Amendments to the Drawings

Remarks/Arguments

FIG.5

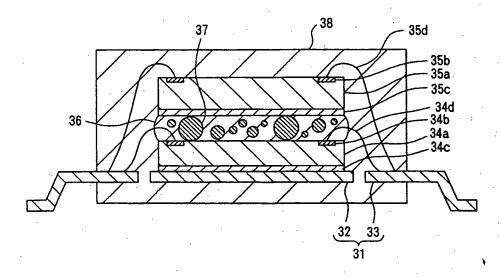
Figures 1-5 are objected to under 37 CFR 1.83(a) as not showing every feature of the invention specified in the claims. In particular, claim 11 recites that the *radius* of the globular particle is practically equal to a thickness of the insulating spacer whereas, Figures 1-5 show that the *diameter* of the globular particle is practically equal to a thickness of the insulating spacer.

In response, the term "radius" in claim 11 is changed to "diameter". Thus, the drawings now show all features of the claims and the objection should be withdrawn.

FIG.6

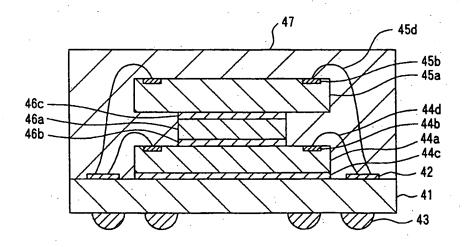
Figure 6 is objected to under MPEP 608.02(g) as lacking the legend --Prior Art--. In response, Figure 6 is amended to include the legend --Prior Art--. A replacement drawing sheet and an annotated sheet showing changes are attached.

The drawings are objected to under 37 CFR 1.84(p)(4) because reference characters 44a and 46a have both been used to designate the mirror chip. In response, applicant notes that in Figure 6, reference character 44a properly designates the lower semiconductor chip while reference character 46a designates the mirror chip. However, in one location in paragraph [0003] of the specification, mirror chip 46a is mistakenly referred to as semiconductor chip 44a. Paragraph [0003] is amended to correct this error, thereby overcoming the objections to the drawings.

The drawings are further objected to under 37 CFR 1.84(p)(4) because reference characters 44b has been used to designate both an electronic pad and a semiconductor chip. In response, applicant notes that in Figure 6, reference character 44b properly designates only the electronic pad. However, in one location in paragraph [0004] of the specification, semiconductor chip 45a is improperly designated as "44b". Paragraph [0004] is amended to correct this error, thereby overcoming the objections to the drawings.

The attached sheet of drawings includes changes to Figure 6. This sheet, which includes Figure 5, replaces the original sheet including Figures 5 and 6. In Figure 6, the legend --Prior Art-- has been added.

"PRIOR ART"
